SUBDIVISION REVIEW SHEET

CASE NO.: C8-2022-0257.0A

SUBDIVISION NAME: Regiene Subdivision

CITY OF AUSTIN –DEVELOPMENT SERVICES DEPARTMENT
SUBDIVISION APPLICATION – MASTER COMMENT REPORT

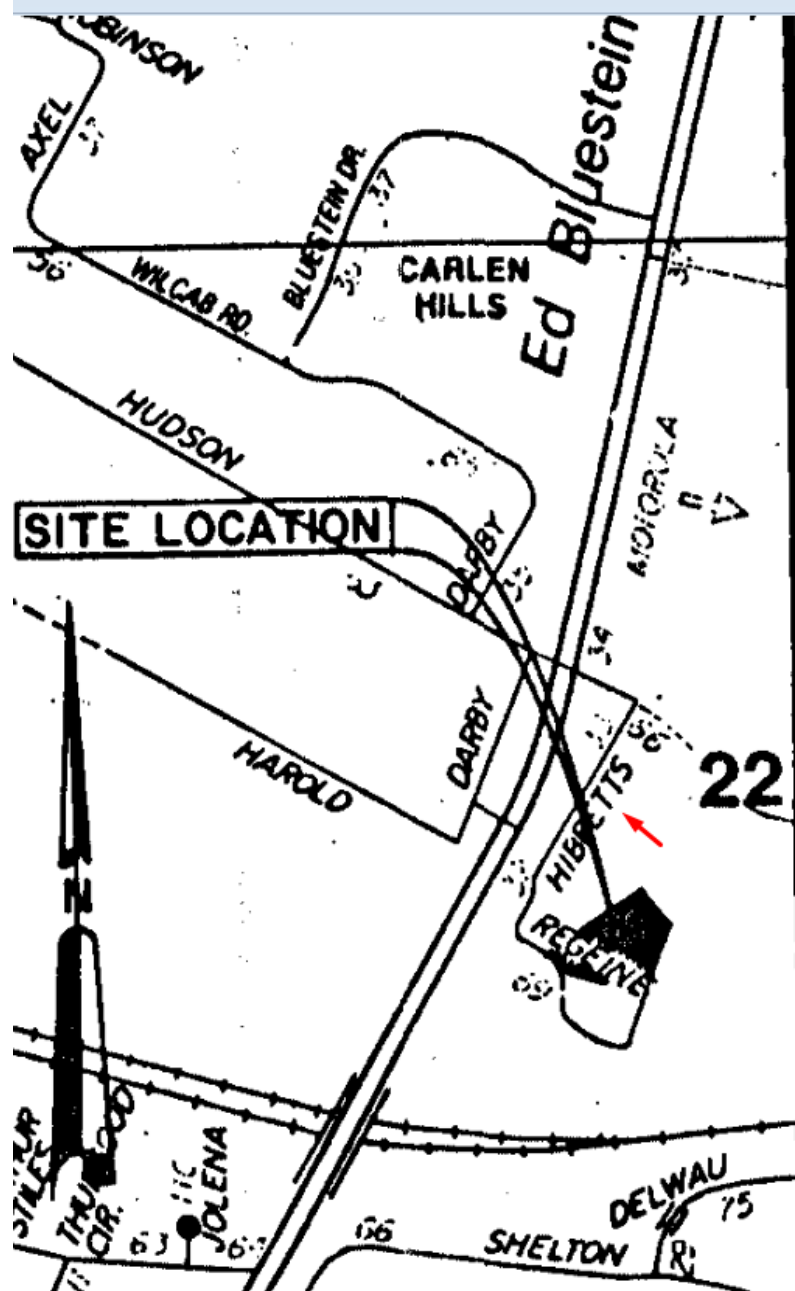
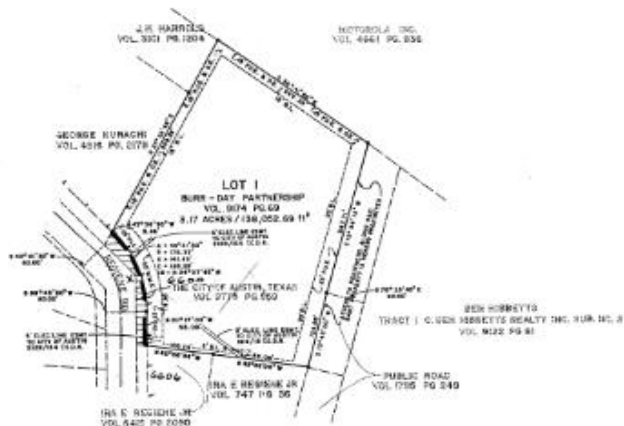
AD1: This plat review is rejected for the following reasons:

AD2: Please include the street label of HIBBETTS RD on sheet 1 and sheet 2. See snapshot below: Green arrow in aerial below is HIBBETTS RD. Two street signs of HIBBETTS RD at the intersection of REGIENE RD/HIBBETTS RD and HUDSON ST/HIBBETTS RD, included below. Also included is a subdivision below which includes HIBBETTS RD.
